Remaining TBDs to be resolved

Pete Anslow, Ciena

40Gb/s Ethernet Single-mode Fibre PMD Task Force, May 2010

Eye mask from G.959.1 compared with old mask

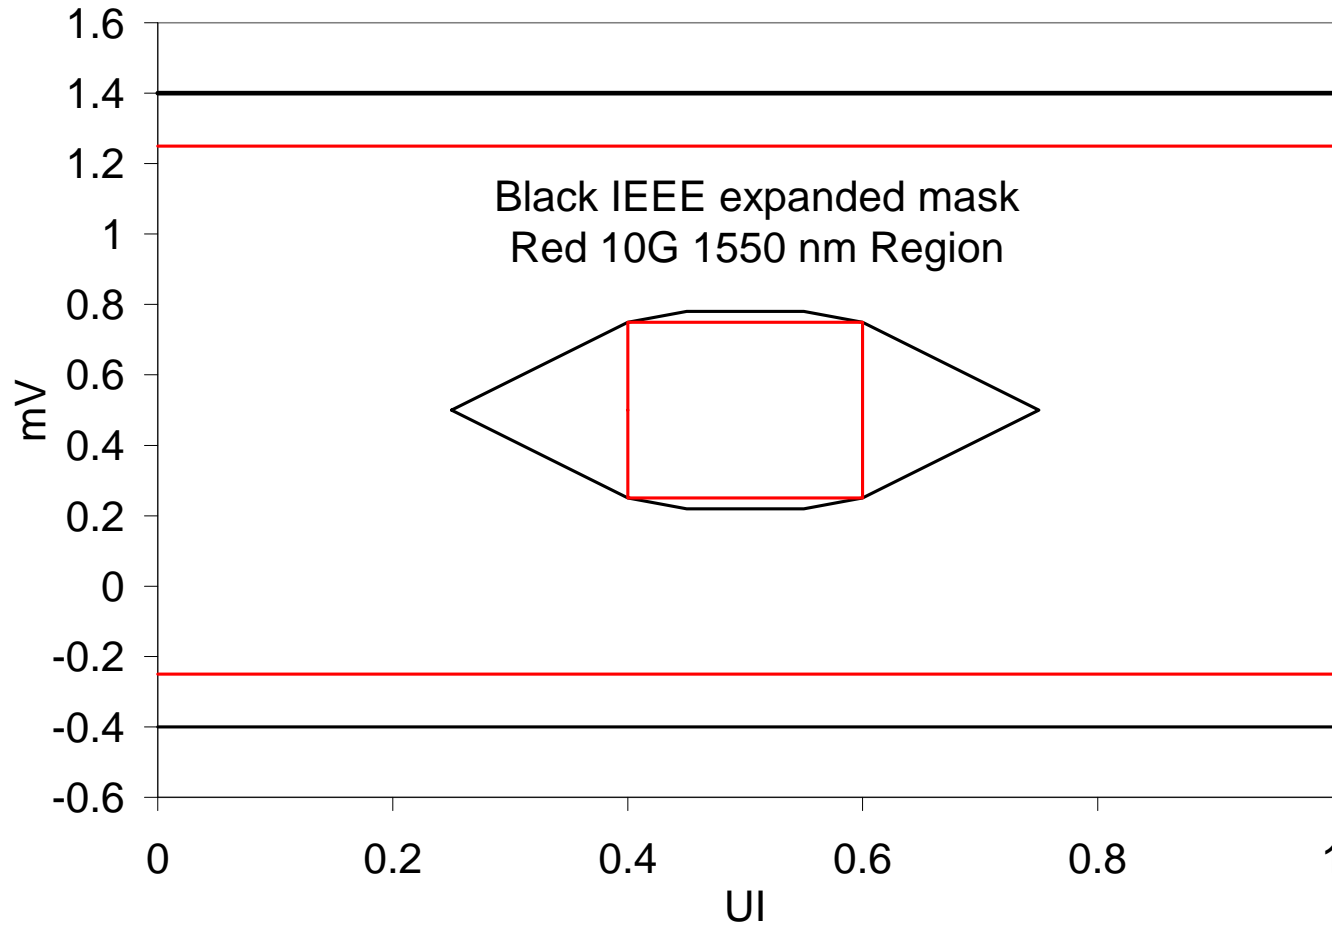
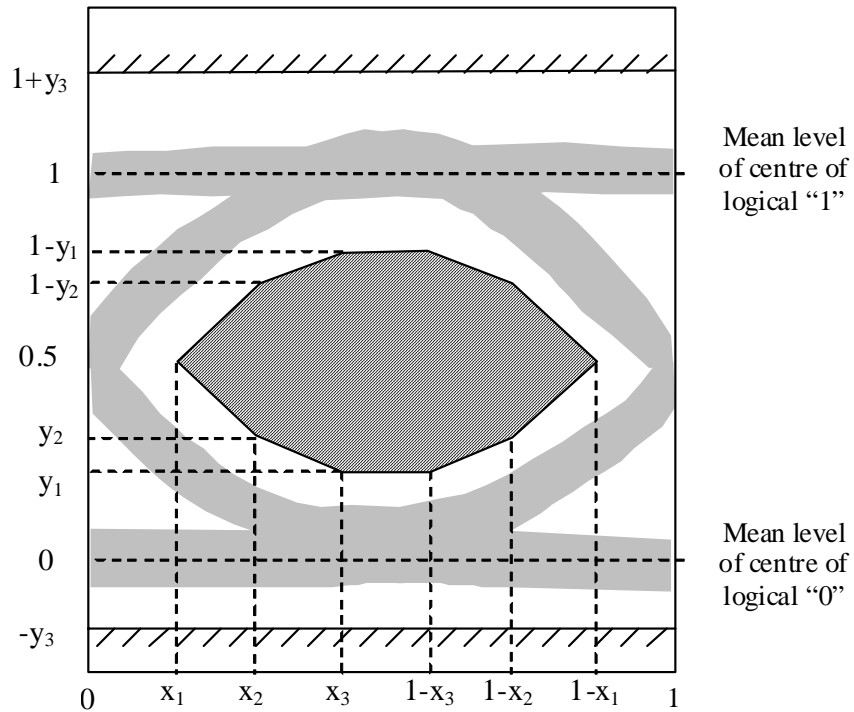
Tx Eye Mask

Proposal {0.25, 0.4, 0.45, 0.22, 0.25, 0.4}
